Work Order ID 112791

Item Name: Fwd Crosstube

DART AEROSPACE LTD		Work Order:	112791
Description: Crosstube High Fwd (206B)		Part Number:	D206-667-101
Inspection Dwg: D206-667-141	Rev: C		Page 1 of 1

DRAWING NO. D206-667-141	TITLE CROSSTUBE ASS'Y (206B HIGH FWD)	REV. C	DART AEROSPACE LTD ENGINEERING ORDER		D.E.O. NO. D206-667-141-C-1	SHEET NO. SHEET 1 OF 1	SCALE NTS
DRAWN <i>q</i>	CHECKED <i>ASS</i>	MFG. APPR. <i>JD</i>	APPROVED <i>WD</i>		DE APPR. <i>HA</i>		
DATE 11.07.15	DATE 11.07.20	DATE 11.07.21	DATE 11/27/21		DATE 11.07.21

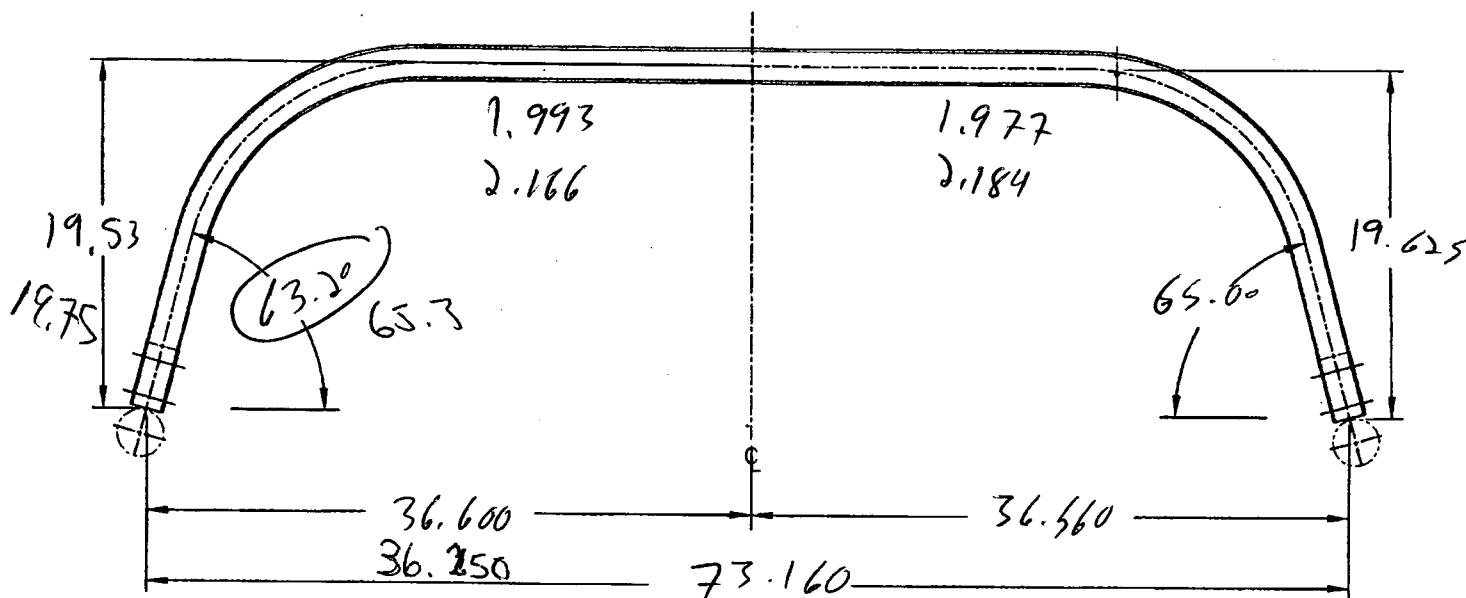
Root Cause	Date	Step	Qty	Description of work order update or non-conformance	Initial Chief Eng	Action Description	Sign & Date	Verification	QC Inspector
Design	15.07.24	1		ANGLE DIM IS NOT WITHIN TOLERANCE PER XTUBE BEND DIM SHEET	A.P. 15.07.24	BASED ON TEST FIT OF WO 112788 RECOMMEND SCRAP. INSTALLATION ISSUES DUE TO MISALIGNMENT tried to Re-Bend to Recover Angles. Did Not Work	A.P. 15.07.24		
Doc/Data									
Equip/Tooling									
Handling/Pre									
Material									
Operator									
Offset/Setup									
Process									
Supplier									
Training									
Transport									
Unapproved

DRAWING NO. D206-667-141	TITLE CROSSTUBE ASS'Y (206B HIGH FWD)	REV. C	DART AEROSPACE LTD ENGINEERING ORDER		D.E.O. NO. D206-667-141-C-2	SHEET NO. SHEET 1 OF 1	SCALE NTS
DRAWN AJS	CHECKED J	MFG. APPR. E	APPROVED AP		DE APPR. H		
DATE 12.08.02	DATE 12.08.02	DATE 12.08.02	DATE 12.08.02		DATE 12.08.02

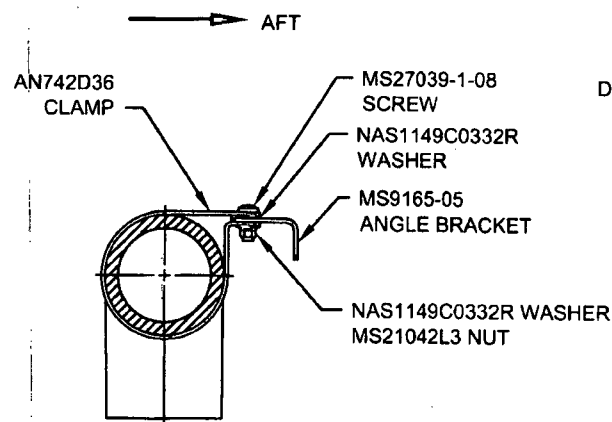
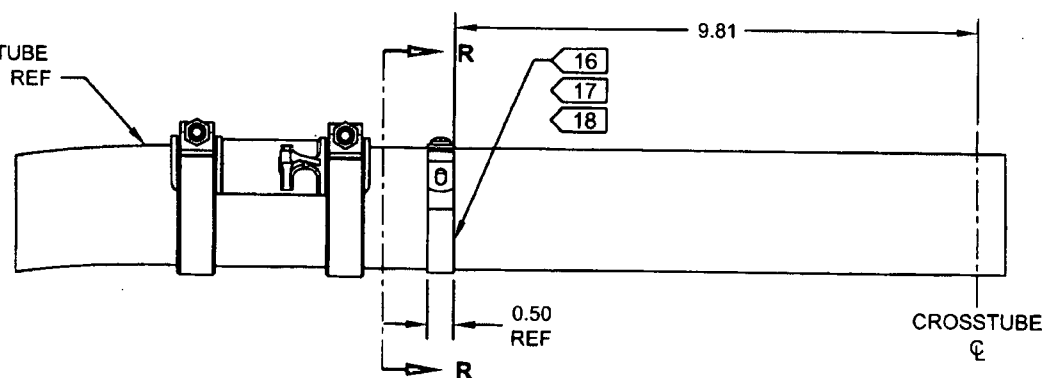
ADD ELECTRICAL GROUNDING STRAP

ADD

ADD
